## Natural Environment and Climate Change

### Referral Response - DA2017/0385 – Private Hospital, Terrey Hills

### **Current Referral Response - Natural Environment Climate Change - Biodiversity 02/03/2018**

**Figure 1:** Proposed development and APZs for the hospital and adjoining school. Note that the proposed hospital would result in all vegetation within the easement (dotted line) being managed as an APZ.

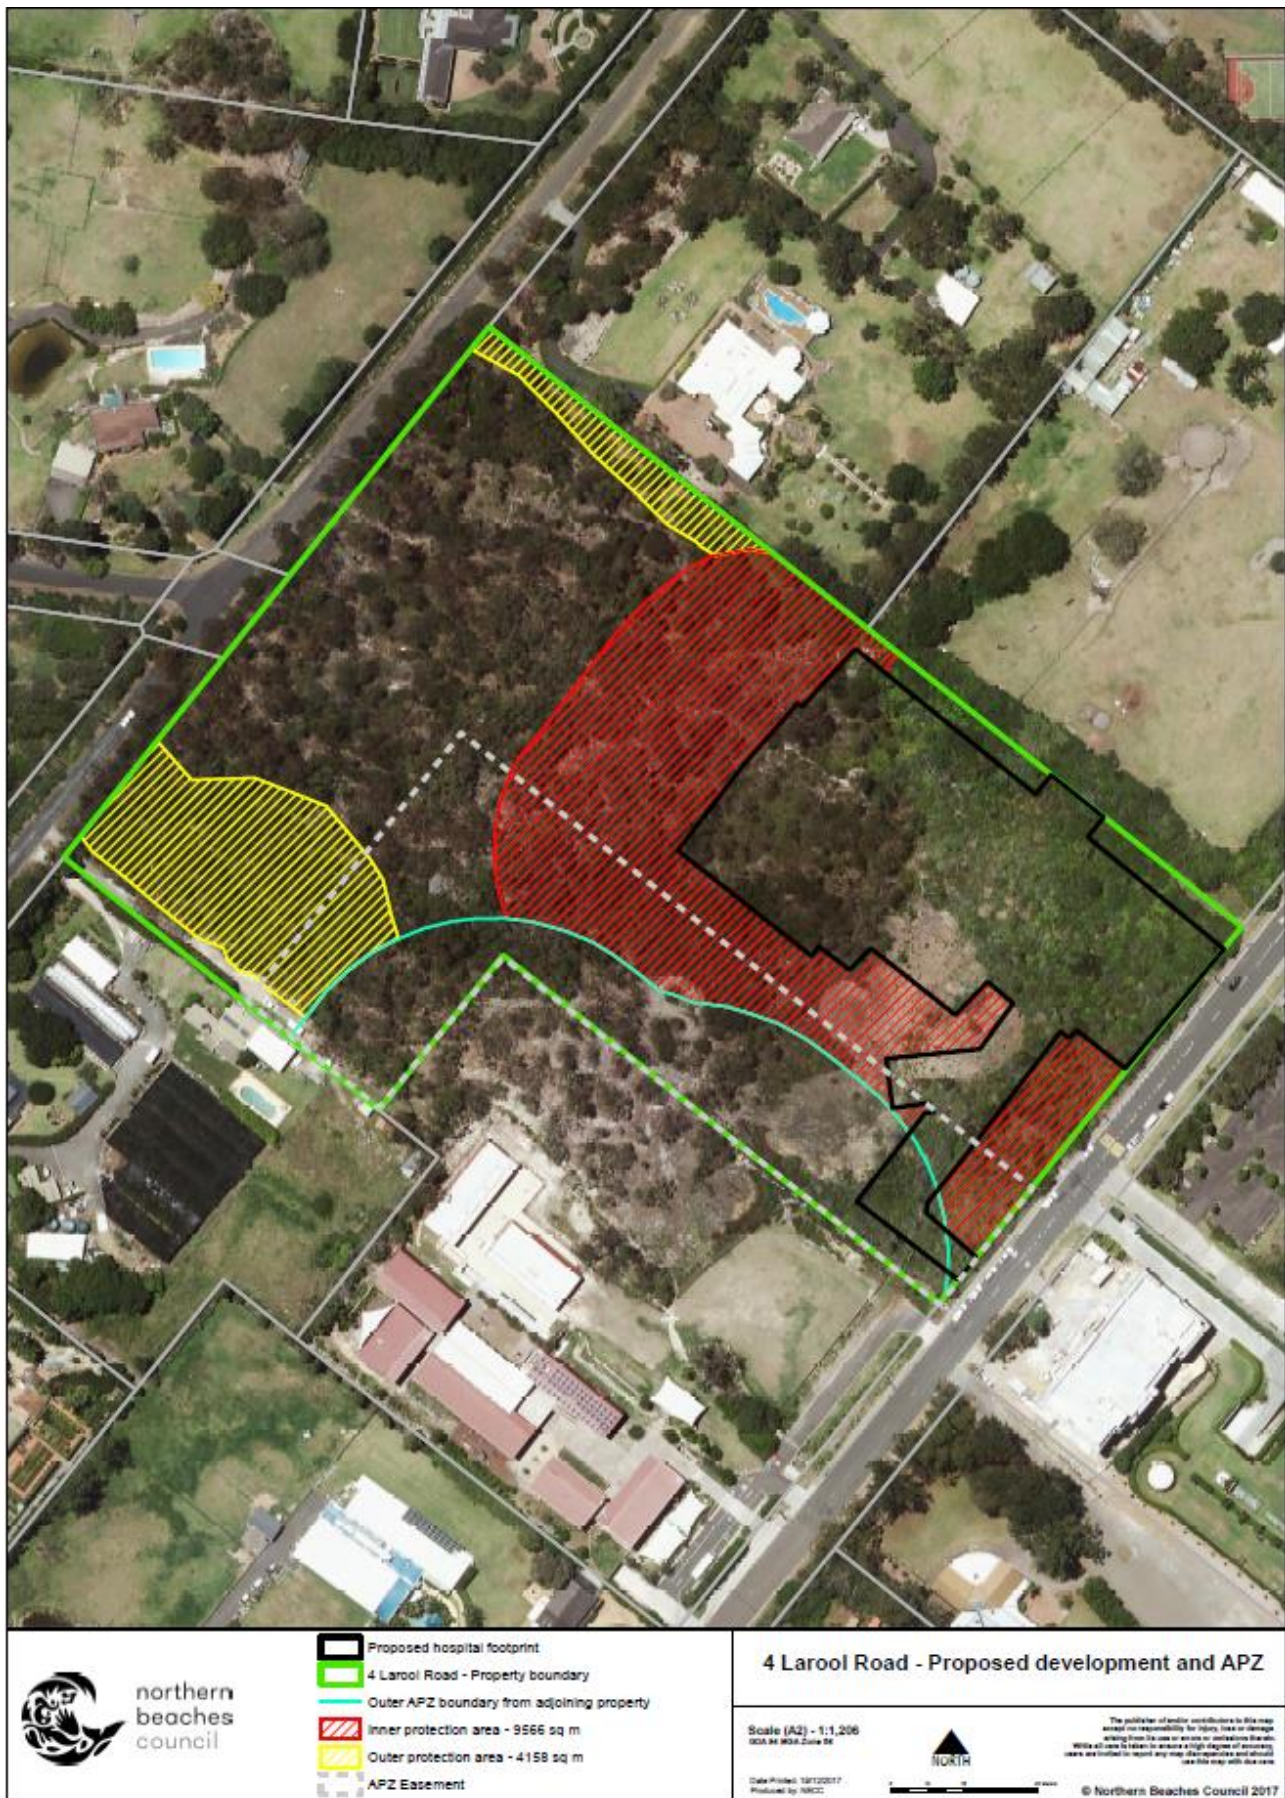
Part of the proposed hospital APZs are located within an existing Section 88b Easement associated with pre-existing APZ requirements for the adjacent German School. The SIS states that the entire easement must be managed as an APZ and therefore does not require assessment in this SIS. Council notes that APZ clearing associated with the German School development consents has been undertaken and does not extend to the easement boundary, but is largely contained within the approved APZs as shown in Figure 1 (see over).

As previously identified, Council's NECC Biodiversity section considers that the extent of clearing currently permitted within the easement is based on what is 'reasonably necessary' for management of the school APZs. Council's assessment of what is reasonably necessary in terms of managing the APZ within the easement is based on the requirements of Planning for Bushfire Protection 2006 and the existing school development consents (including bushfire reports) which identify APZs within the easement consistent with those mapped in Figure 1. Note that on the basis of the SIS, the entire easement would be an APZ including the area which appears to fall outside both the school and hospital APZs (see north-west of easement in Figure 1).

Vegetation within the easement but outside of the approved school APZs includes both Endangered Ecological Communities and habitat for threatened species. Impact assessments within the SIS do not account for these areas on the premise that clearing is already permitted within the entire easement.
